ACCESSIBILITY ASSESSMENT REPORT

PROJECT:	30-36 Light Street & 42 Walker Street Casino NSW 2470
STAGE:	Development Consent Phase
REFERENCE:	22074.4-Access
DATE:	23 rd January 2024
CLIENT:	Brewster Murray

Figure 2.1 – Pedestrian entrance/s

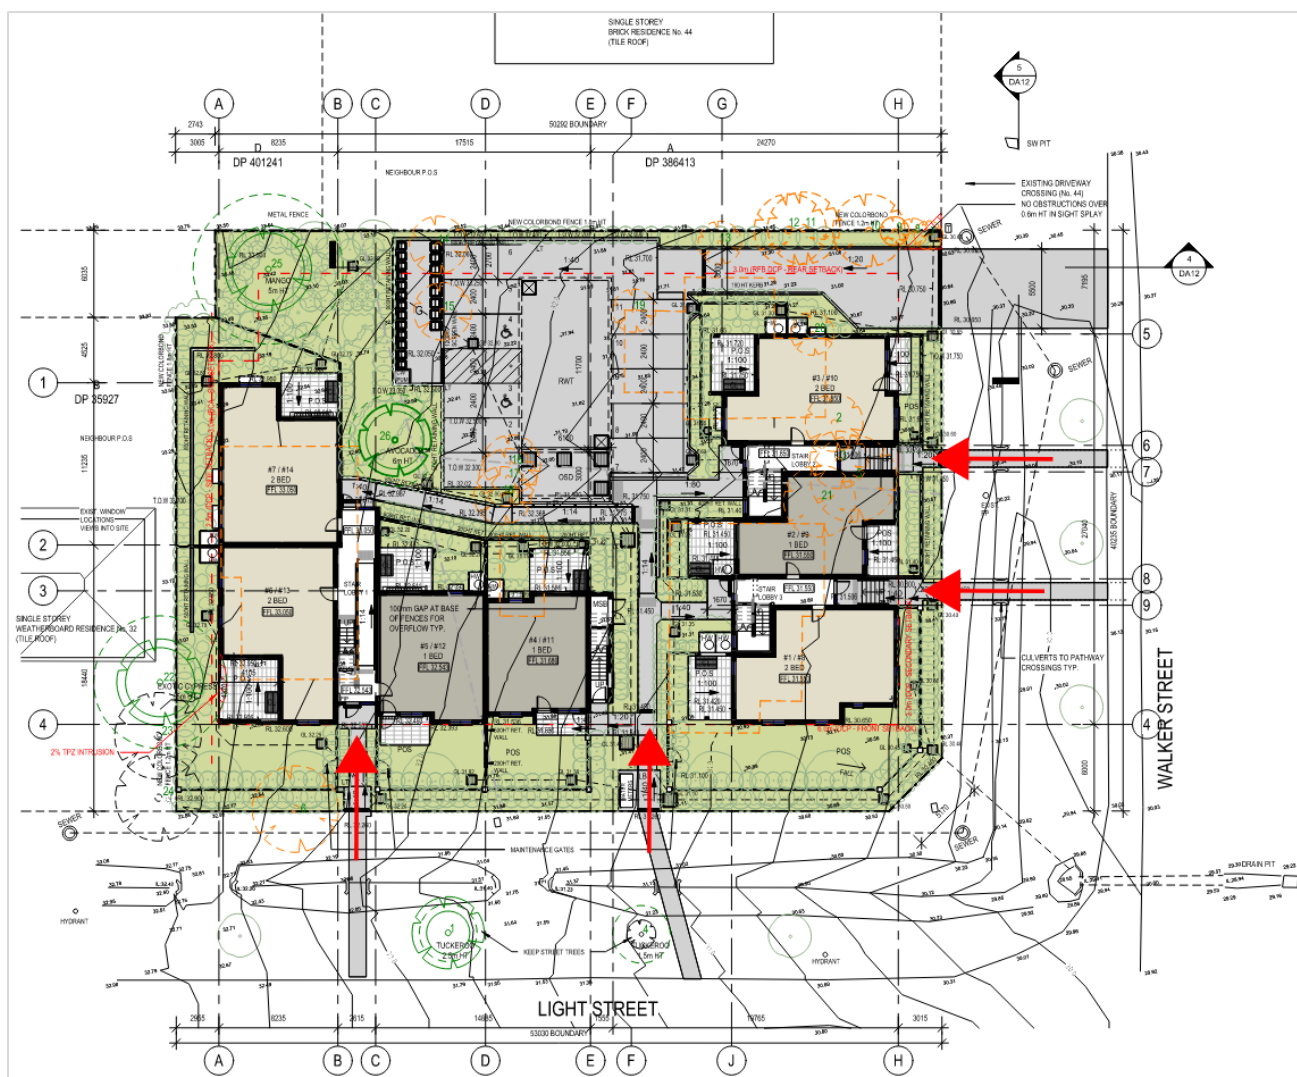
Referring to Figure 2.1 below, the site is provided with multiple pedestrian entrances, with the accessible pedestrian entrance/s from the allotment boundary assessed as shown (highlighted **red**).

<p><u>Comment/s</u></p> <p>Access to each building, extending from the corresponding pedestrian entrances at the allotment boundary as well as between buildings, is to be provided in accordance with the requirements of AS1428.1-2009, which includes (but is not limited to) the following –</p> <ul style="list-style-type: none"> (a) Walkways and landings complying with Clause 10.2 and 10.8.1 of AS1428.1-2009; and (b) Ramps complying and landings complying with Clause 10.3 and 10.8.1 of AS1428.1-2009; and (c) Doorway circulation spaces and door hardware complying with Clause 13 of AS1428.1-2009; and (d) Continuous accessible paths of travel complying with Clause 6 of AS1428.1-2009; and (e) Ground surfaces on continuous accessible paths of travel and circulation spaces complying with Clause 7 of AS1428.1-2009; and (f) Intercommunication panels and any door controls located in accordance with 13.5.3 of AS1428.1-2009.

Figure 2.1 – Proposed adaptable units

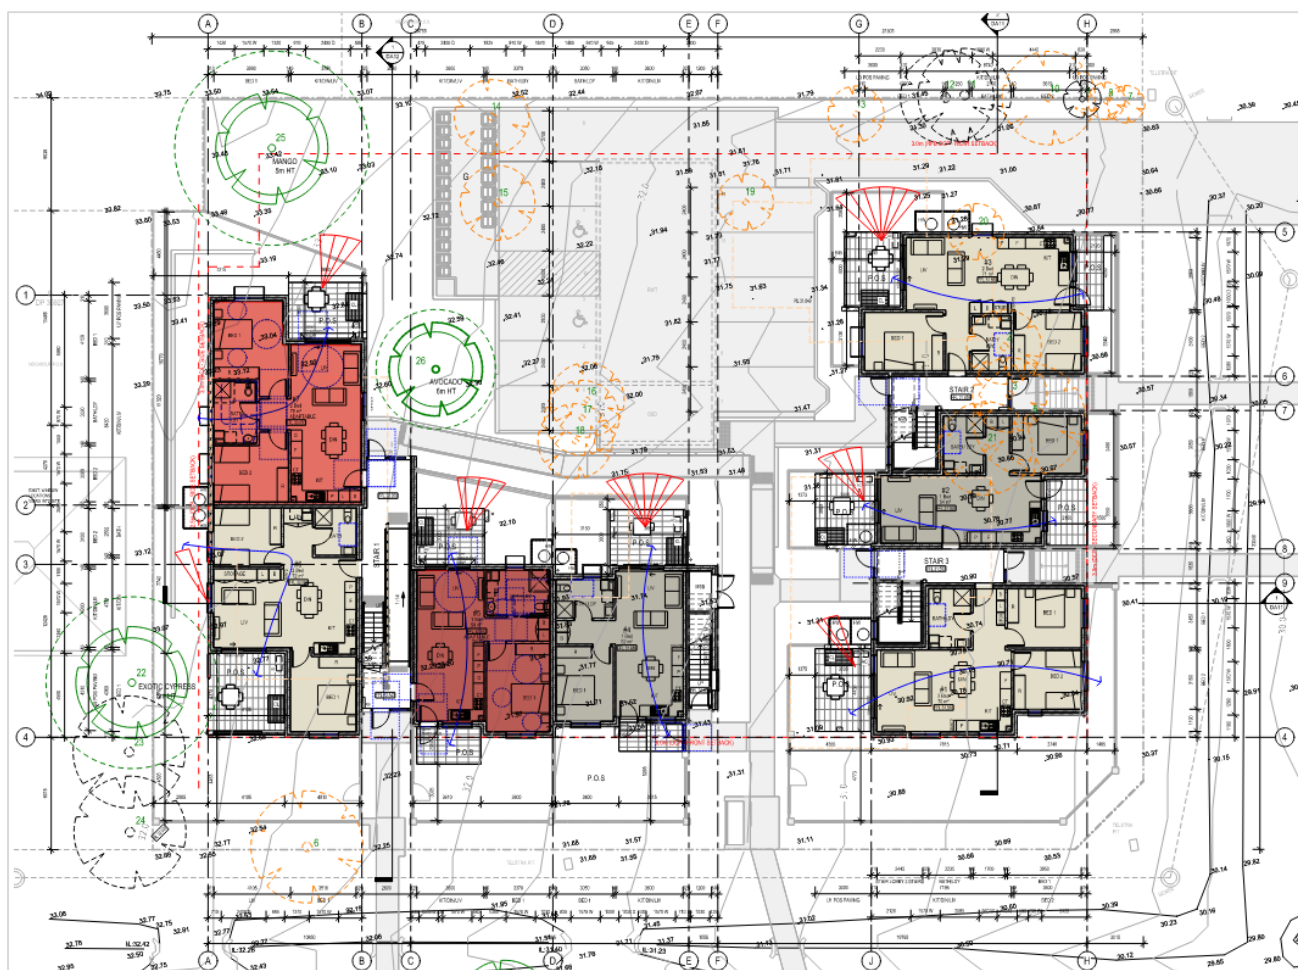
The proposed development is understood to consist of two (2) units that are proposed to meet the Class C provisions of the Adaptable Housing Australian Standard AS4299-1995, being Unit 5 and Unit 7, as highlighted in the figure below.
